To: Melissa McGrath (Barkers & Associates)
From: Katherine Overwater KDC District Plan Team Leader
Date: 20/12/22
Subject: The Rise Limited, Private Plan Change PPC83: Request – Further Information request, pursuant to Clause 23 of Schedule 1, RMA

Request for Roading Information

Date: 14/12/2022
 Resource consent: Private Plan Change 83
 Site Location: Cove Road/Mangawhai Heads Road

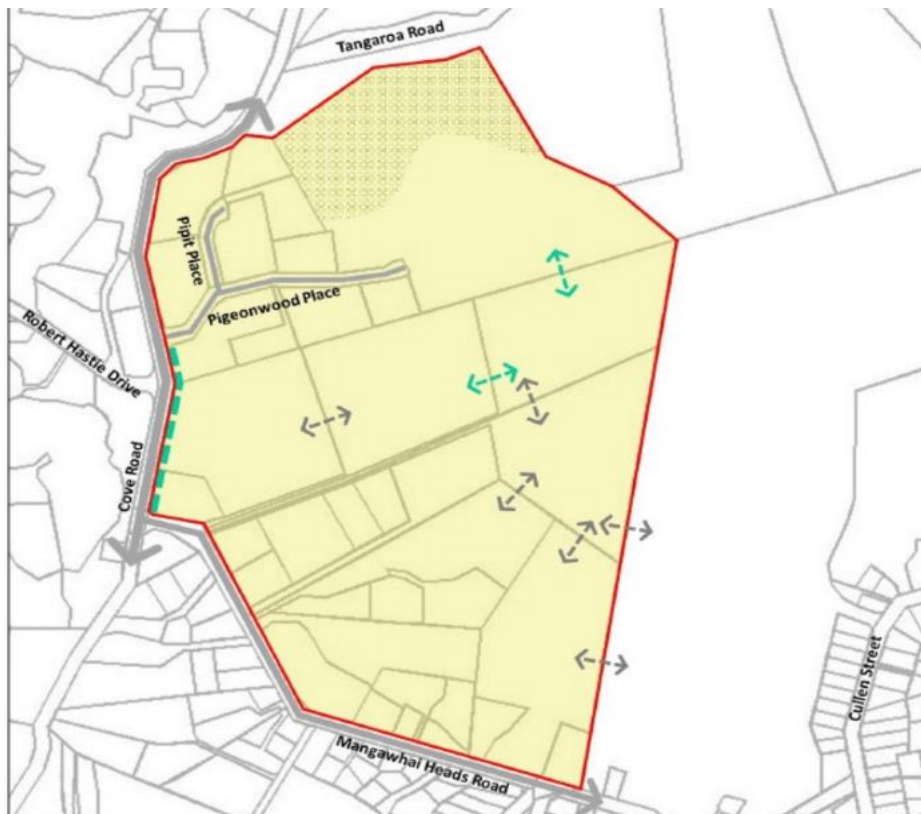
1. TIA states that the intersection of Pigeonwood Place and Cove Road might warrant a CHR - request applicant to provide us an approximate estimate of lots accessed of Pigeonwood Place/Cove Road and an approximate estimate of lots accessed off Mangawhai Heads Road.
2. Precinct Plan – this should include indicative collector roads and intersection locations with Cove and Mangawhai, otherwise it could develop as a bunch of cul-de-sacs if there are multiple landowners

9. *The Plan outlines the indicative street and cycling connection on Mangawhai Heads Road but does not address the effects on the existing footpath on Mangawhai Heads Road and have shown an indicative off road shared path connecting to an existing footpath which would not be ideal. Request applicant to address this.*

Request applicant to remove the wording “in accordance with Cove Road North Precinct Map 1 and Cove Road North Precinct Concept Plan 1” as the active modes connection has not been addressed completely.
